**DOCUMENT 00 90 00
ADDENDUM**

ADDENDUM NO. [1] Date: March 30, 2021

**RE: SCHOOL DISTRICT OF HOLMEN
EMPIRE STADIUM COLONNADE REPLACEMENT
1001 McHUGH RD
HOLMEN, WISCONSIN 54636
HSR PROJECT NO. 21003**

FIRST FLOOR AND SOFFIT PLAN

KEY NOTES RCP

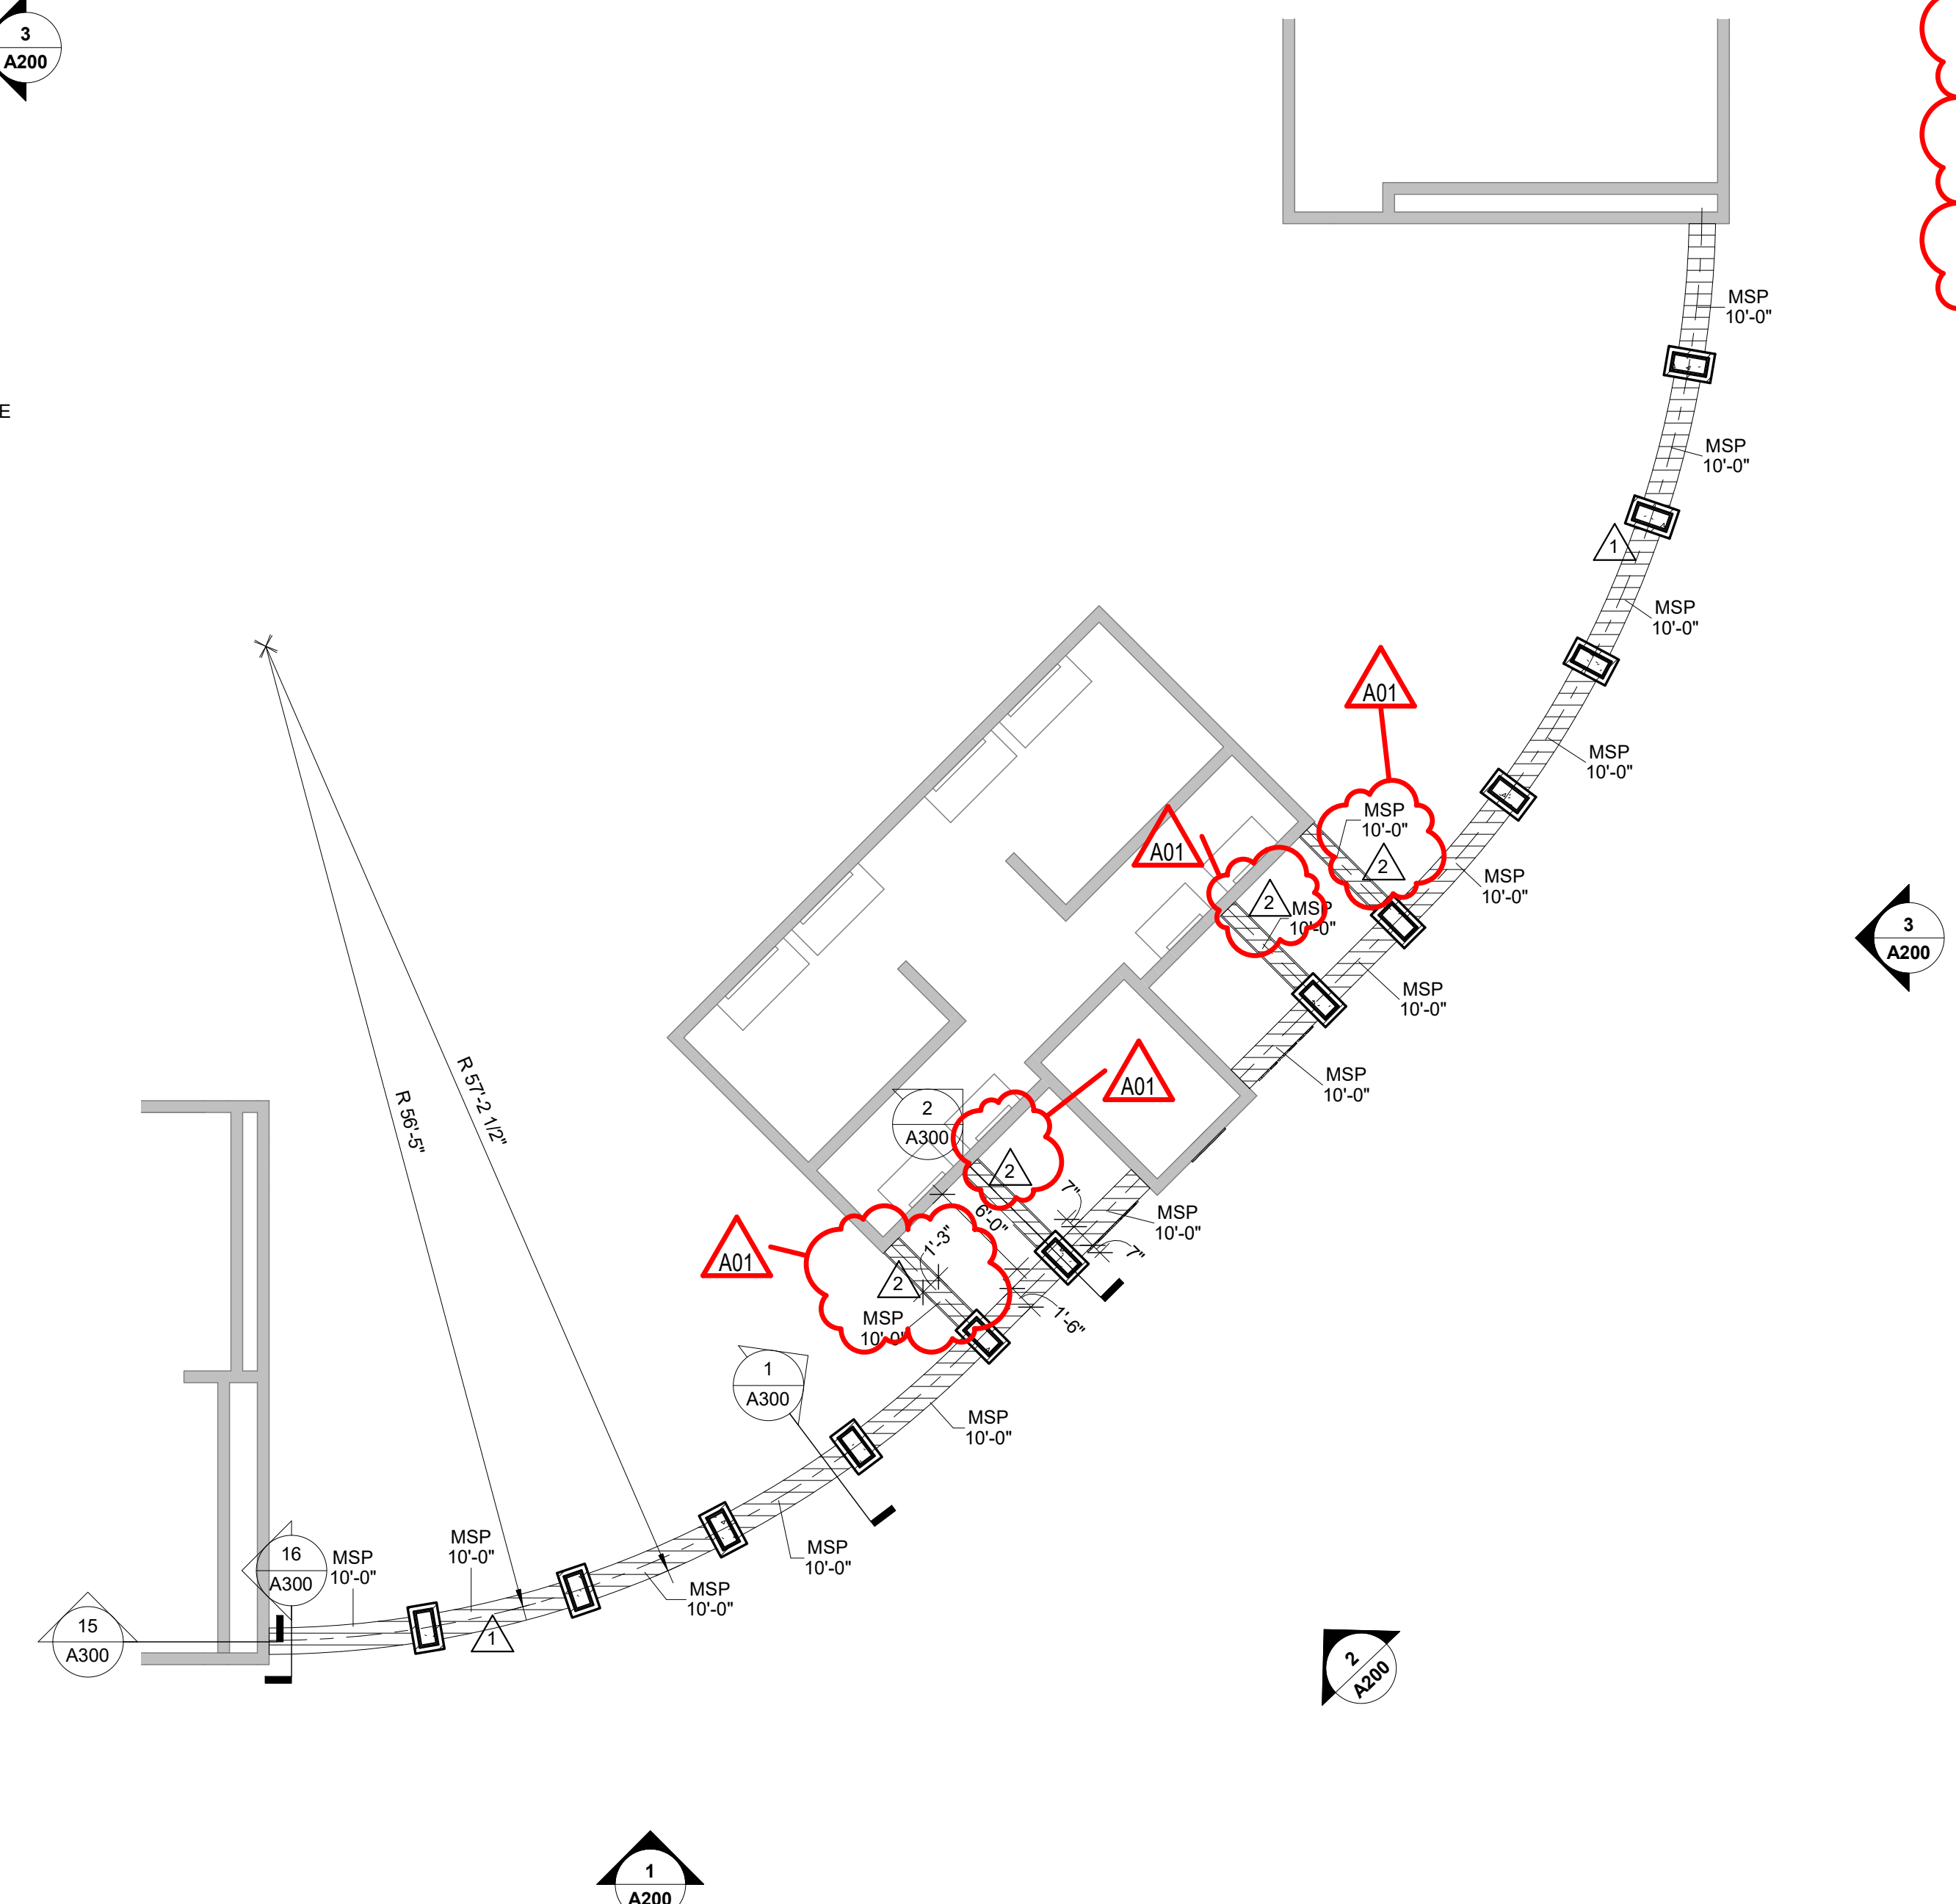
2. Sheet A100 FIRST FLOOR AND SOFFIT PLAN 30 x 42 attached hereto
 - a. Revisions clouded on Drawing.
 - b. Wall type A3 added for soffit construction.
 - c. Clarification of base bid and alternate scope for paving in Key Notes.
3. Sheet E100 – ELECTRICAL LIGHTING PLAN: No Drawing reissued.
 - a. Light Fixture Schedule: Owner to purchase and furnish type "OA" light fixtures to the electrical contractor for installation.
Contractor to provide all dimming controls as indicated in the light fixture schedule remarks.

PARTITION TYPE	STUD SPACING	PARTITION WIDTH		R-VALUE	NOTES
		ACTUAL	NOMINAL		
A3	16" O.C.	5"	5"	-	-

- CENTER OF NEW STEEL TUBE FRAMING
- FOR SOFFITS PERPENDICULAR TO COLUMNS USE WALL TYPE A3 AND THE OVERALL WIDTH IS 1'-3"
